Re: LANCARFFE, BODMIN – STABLE BLOCK

Further to our visit to the property on Thursday 29th June 2023, and our limited inspection of the stable block, together with having reviewed your supporting Planning Application documents, we comment as follows.

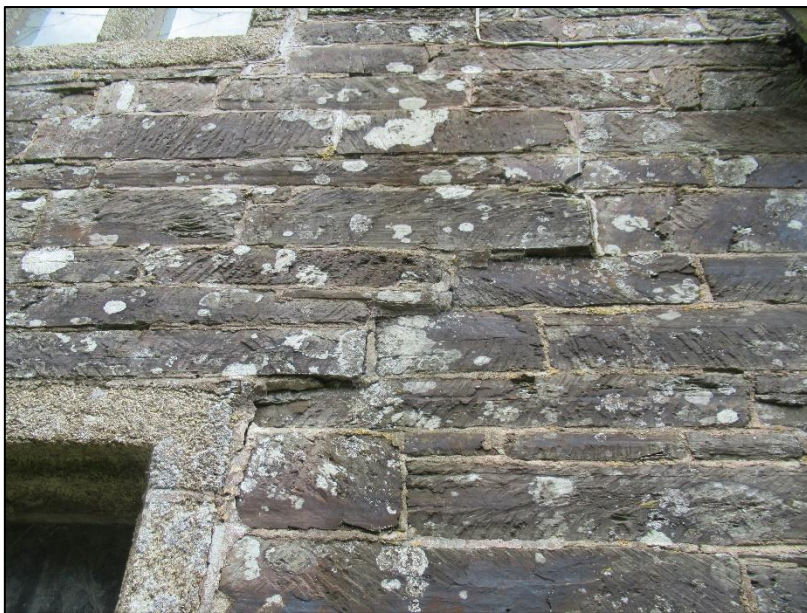
The attic floor structure of boarding and joists is quite weak, with the joists being set at 800c/c; however, it is proposed to retain the current usage of light storage and it is not intended to attach a ceiling to the underside of the floor structure, thereby adding more weight and making it more vulnerable to excessive deflections.

North west wall of middle barn suffering from longstanding marginal differential transverse settlement.

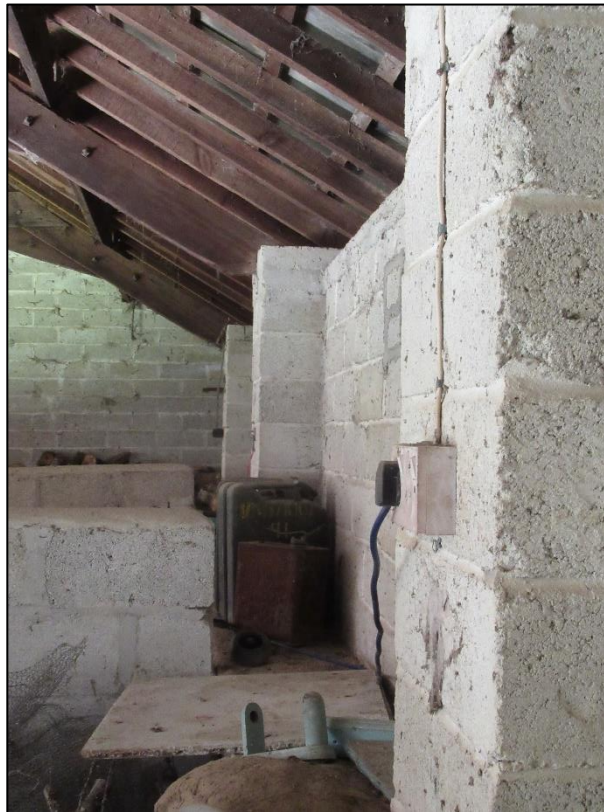
There is evidence of slight long-term structural movement associated with the rear north west wall of the central barn, which as outlined, includes concrete blockwork built off an original random rubble stone wall. The principal scissor roof trusses are tied just above eaves and show minimal deflection, but it is evident that the north west wall has rotated outwards slightly, including the lower random rubble stone wall off which the blockwork is built.

The wall and piers are built on the outer edge of the stone wall, resulting in a degree of eccentricity with the loading arrangement onto the stone wall, and it is thought that there has been some marginal transverse differential settlement of the stone wall and its substructure as a result of being on the downhill aspect of the site, shallowly founded poor quality bearing ground, very possibly made worse by inadequate discharge of roof rainwater.

It is thought that this movement probably occurred fairly soon after the blockwork was constructed on top of the wall in C20. It has resulted in reflective cracking where the wall abuts return internal blockwork walls, with noticeable cracking evident.

As part of the upgrading of the building we would recommend that the evident cracking is stitched and repointed, the roof rainwater gutters and downpipes are replaced or upgraded, allowing for the downpipes to be collected in suitable gulleys and discharged at least 5m away from the building.

In addition, the substructure and dwarf wall stonework should be locally repointed where required and open jointed, with the situation subsequently monitored.
